SUNDRY NOTICES AND REPORTS ON WELLS
Do not use this form for proposals to drill or to re-enter an abandoned well. Use form 3160-3 (APD) for such proposals.

This sundry is to clarify the original COA's regarding pressure control equipment. The 5M BOP will be utilized on these wells after the surface shoe, and the 10M BOP (that is already included in the COAs) will be utilized after the intermediate shoe and therefore used for the production hole section accordingly.

**PECOS DISTRICT
DRILLING CONDITIONS OF APPROVAL**

CO YETI 15 22 FED COM 0051H
LOCATION: Section 15, T25S, R32E, NMPM
SURFACE HOLE FOOTAGE: 10'/N & 1335'/E
BOTTOM HOLE FOOTAGE: 100'/S & 2090'/E

BLOWOUT PREVENTER SCHEMATIC

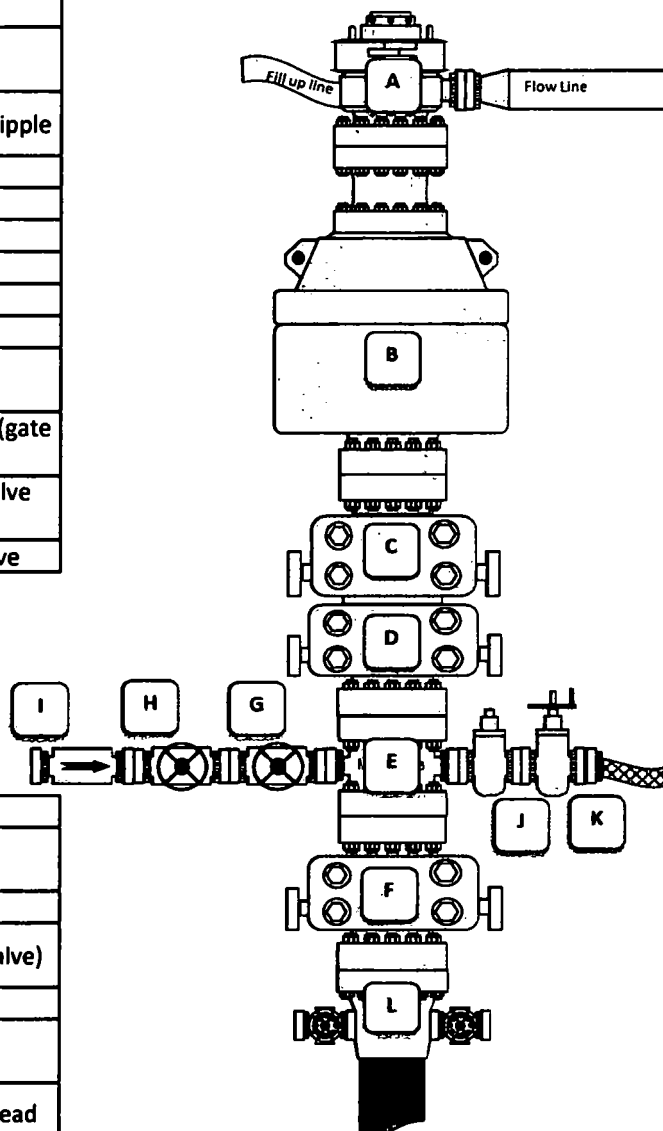
See attached 5M Intermediate BOP and choke manifold

- a. Minimum working pressure of the blowout preventer (BOP) and related equipment (BOPE) required for drilling below the surface casing shoe shall be **5000 (5M)** psi.
- b. Minimum working pressure of the blowout preventer (BOP) and related equipment (BOPE) required for drilling below the intermediate casing shoe shall be **10,000 (10M)** psi.
